SITE PLAN & ARCHITECTURAL COMMISSION AGENDA DECEMBER 2, 2016

- 50.1 AC-16-115 Consideration of plans for a 2,856 square foot general office/medical office building on a 0.43 acre lot within Phase 3 of the West View Village PUD. The subject property is zoned SFR-10/PD (Single Family Residential - 10 dwelling units per gross acre) with Planned Unit Development Overlay Zone and located at the southeast corner of Lozier Lane and Meadows Lane. (Young Family Trust, David F. Young, Trustee, Applicant; Richard Stevens & Associates, Agent).

Consideration of plans for a 2,856 square foot general office/medical office building on a 0.43 acre lot within Phase 3 of the West View Village PUD. The subject property is zoned SFR-10/PD (Single Family Residential – 10 units per gross acre with a Planned Unit Development Overlay) and located at the southeast corner of Lozier Lane and Meadows Lane (Maptax 372W26DD Tax Lot 1000).

1 SITE PLAN
 SCALE: 1/8" = 1'-0"

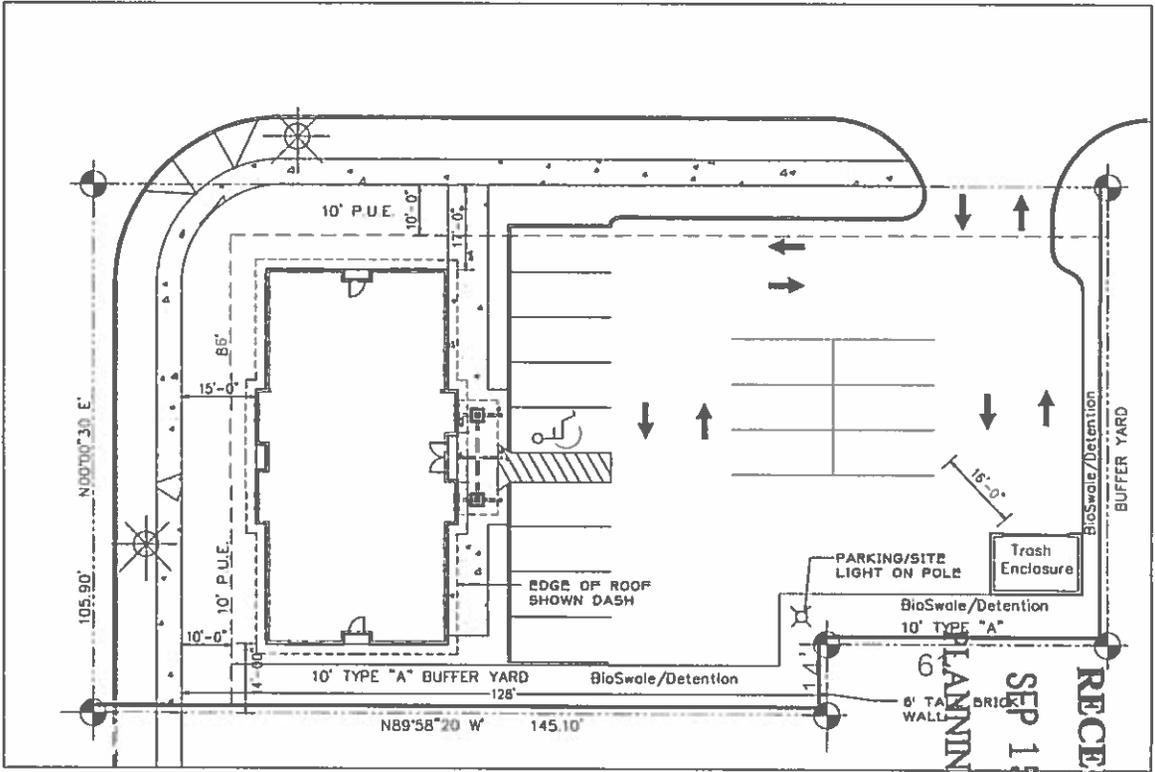
As illustrated in the Parking Requirements table above, it can be found that the submitted Site Plan meets the maximum parking requirements as outlined in Section 10.743. However, the Site Plan does not show the location of the required bicycle parking spaces even though it shows the bike rack detail. A conditions has been included requiring the applicant to submit a revised site plan that shows the location of the required bicycle spaces.

The submitted site plan does not include HVAC equipment. If HVAC equipment is to be provided for this structure, a condition has been included requiring concealment of such equipment per Section 10.782.

1. Prior to the issuance of building permit, the applicant shall:
 - a. Submit a final revised Site Plan to Planning showing the location of the bike rack per Section 10.749, and (if applicable) concealment of HVAC equipment per Section 10.782.
